**PUBLIC INTEREST REVIEW FOR GROUND WATER APPLICATIONS**

TO: Water Rights Section Date 6 August 2015  
 FROM: Ground Water/Hydrology Section Gerald H. Grondin  
Reviewer's Name  
 SUBJECT: Application G-18102 Supersedes review of \_\_\_\_\_  
Date of Review(s)

**A. GENERAL INFORMATION:** Applicant's Name: Dennis Flynn Ranch County: Lake

LAKE 52274 to Crooked Creek

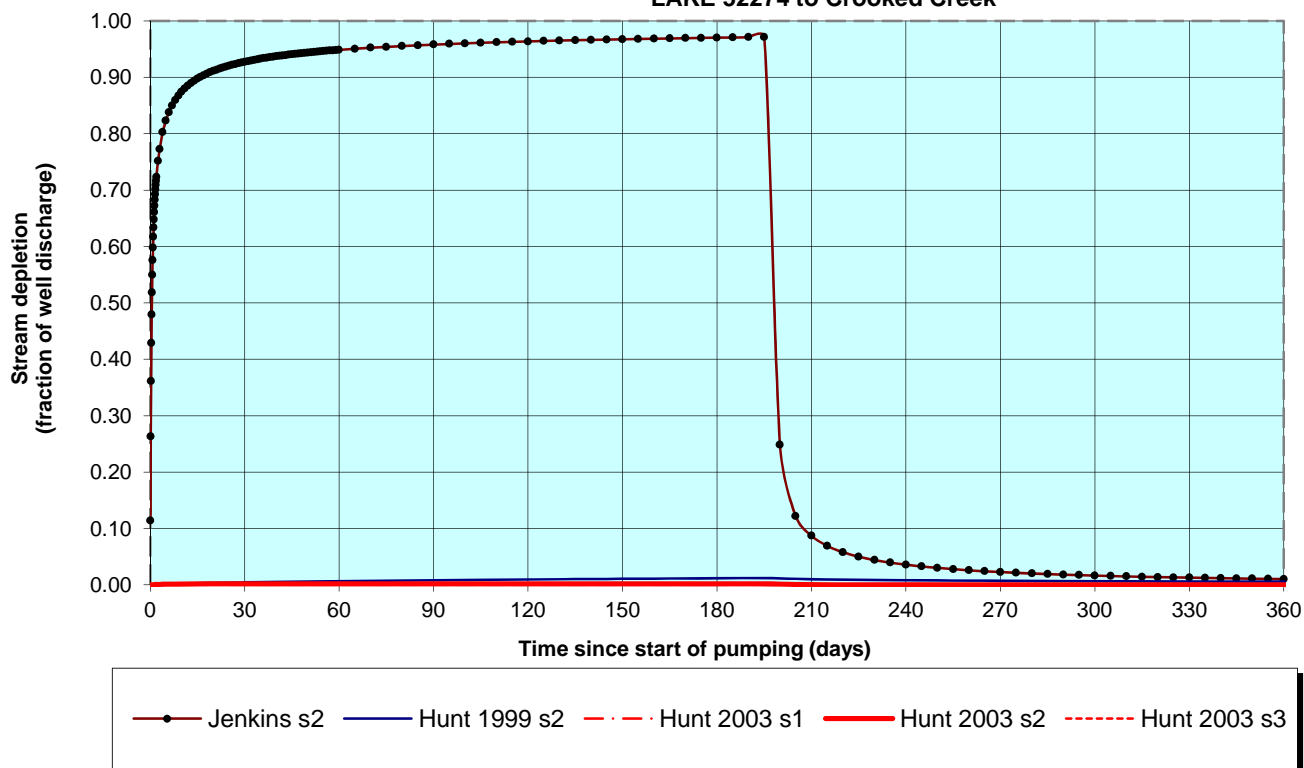
**Hunt (2003) was used to calculate the groundwater pumping interference with Crooked Creek. The calculation used a transmissivity of 2,100 ft<sup>2</sup>/day derived from specific capacity data for nearby well LAKE 1769, an intermediate storage coefficient of 0.001, a 0.042 ft/day vertical hydraulic conductivity for the basin fill (horizontal conductivity divided by 100), and a pro-rated pumping rate of 0.98 cfs (440 gpm) derived by dividing the proposed maximum annual volume (383.9 ac-ft) by the proposed total days of pumping (198 days).**

**Under OAR 690-009, a potential for substantial interference is automatically found given: available data indicating Crooked Creek is a perennial creek; groundwater in the area is unconfined and hydraulically connected to surface water; and the distance from the proposed POA well to the creek is less than 0.25 miles. Also, the proposed maximum pumping rate is greater than one-percent of the natural flow (80% exceedance).**
